**Re: City Point Phase 3 (aka 138 Willoughby Street), Brooklyn, NY
Independent Engineering Review for Superstructure
GMS Project Number 16283**

**INDEPENDENT STRUCTURAL ENGINEERING SUPERSTRUCTURE
PEER REVIEW**

**CITY POINT PHASE 3
NEW YORK, NY**

Figure 1 10th-18th floor slab model

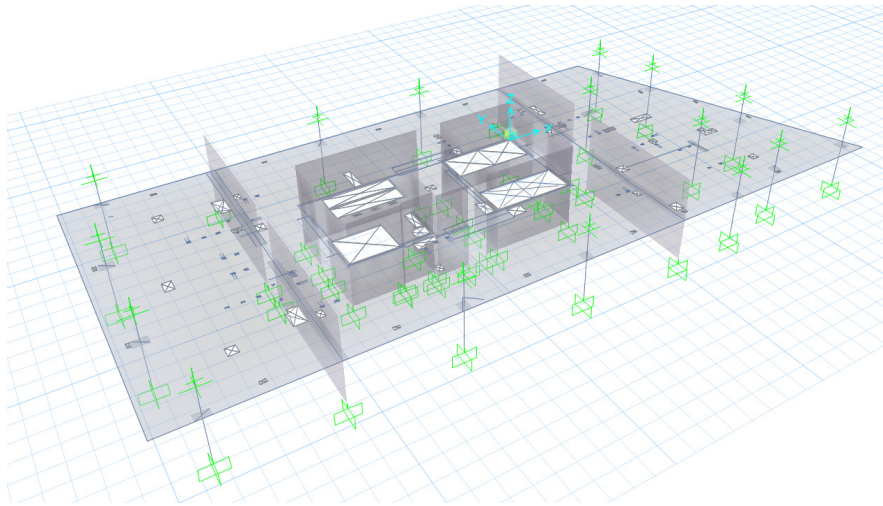
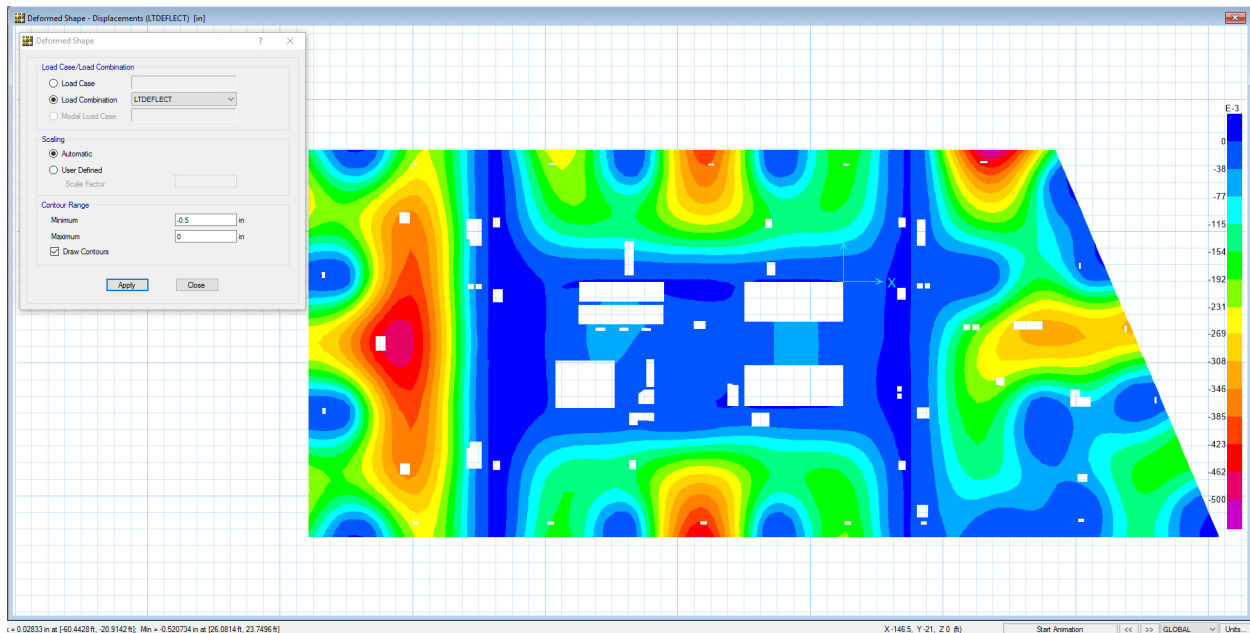
Finite element models of two building floors (10th -18th floor, 52rd -56th floor) were modeled in SAFE. Our models included the following modeling idealizations:

- F'c = 8600psi at 10th -18th floor slab model, F'c=6000psi at 52nd -59th floor slab
- Columns/walls fixed at base below, columns above fix for Rx, Ry only.
- Rigid zone modeled at column locations
- All geometry (including openings) per structural drawings

We verified the slab reinforcement and found them to be adequate. The total long term slab deflection was found to be acceptable. Images of the analysis model and the deflected shapes are shown below.

Figure 5 Building ETABS model 3D view

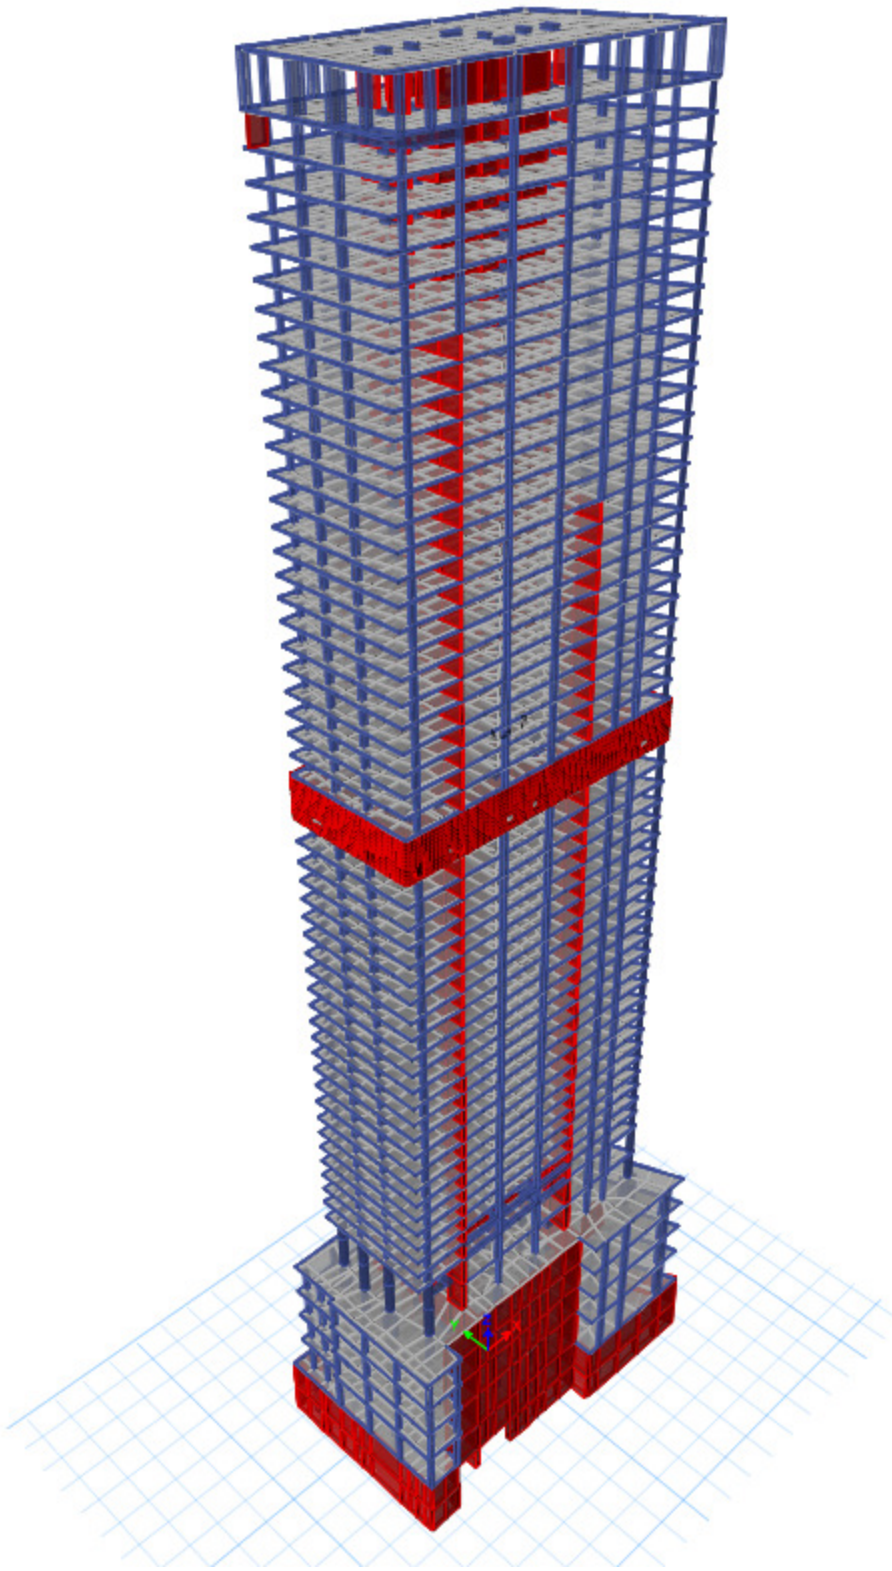
We created an independent structural analysis model using ETABS to estimate the building behavior under lateral loads. Our model included the following modeling idealizations:

- Columns are pinned at each floor
- Inertia-gross modified per ACI coefficients for strength calculations
- The foundation mat is modeled and foundation springs are assigned over the area of the mat based on soil stiffness provided by the geotechnical engineer.
- Slab is modeled with shell elements
- Link beams are modeled with line elements

We performed calculations for a representative portion of the lateral system, as described below, and confirmed its adequacy.

We checked the shear walls at the 2nd floor level and the 33rd floor level for the lateral wind loads from the RWDI. The adequacy of the walls were checked using spColumn. We found that the capacity in the analyzed walls are adequate for the considered loads.
